Site Plan Review Committee (SPRC)

YMCA Project

New Site Plan (SPLN22-00005), GLUP Amendment, and Rezoning

3400, 3422, and 3444 13th Street N. (RPC #15-086-022, -023, -024)

E-W Connection Recommendations

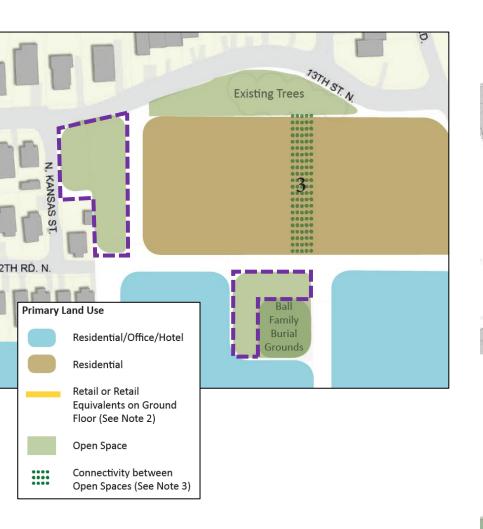
- <u>Pavement material:</u> pavers matching alley/New Kansas Street design or alternative treatment – not simply concrete or asphalt
- Pavement width: minimum 15 feet
- <u>Total width:</u> 50 feet (minimum 40 feet exclusive of Mill Creek building alley)
- <u>Landscaping:</u> trees lining **both** sides of the connection
- <u>Lighting:</u> implement streetlamp style lighting along the connection

- Provide a minimum 40 feet of building separation with a 10-foot path lined with trees
- Explore public path alternatives to connect to 13th Street that do not impact mature tree roots

As Proposed:

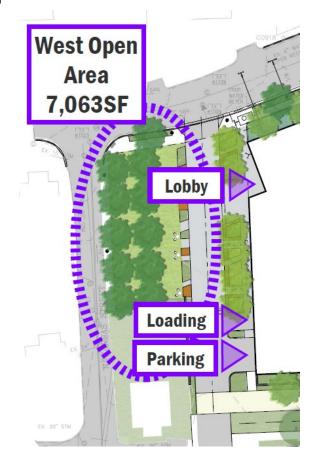
Staff Issues with current proposal

Size of Western public space: GLUP study anticipated about .5 acre

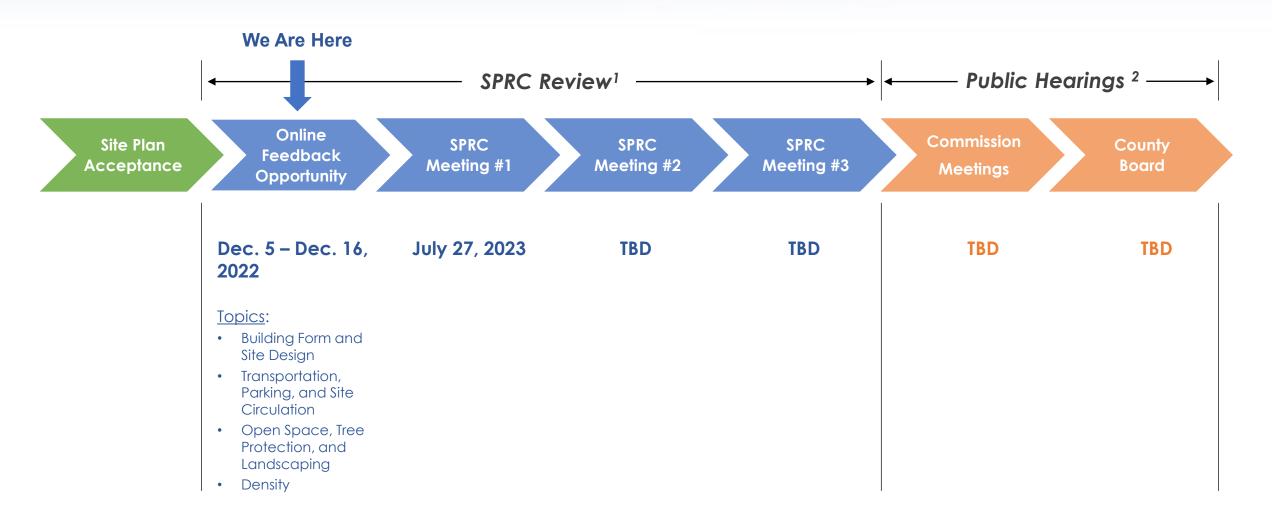
- Principle 12
 - Encouragement of vertical mixed use

iese other YMCA projects show the development potential for vertical-mixed use illdings with residential space above institutions. While only YMCAs are shown, this propach could be a possibility for the American Legion site as well.
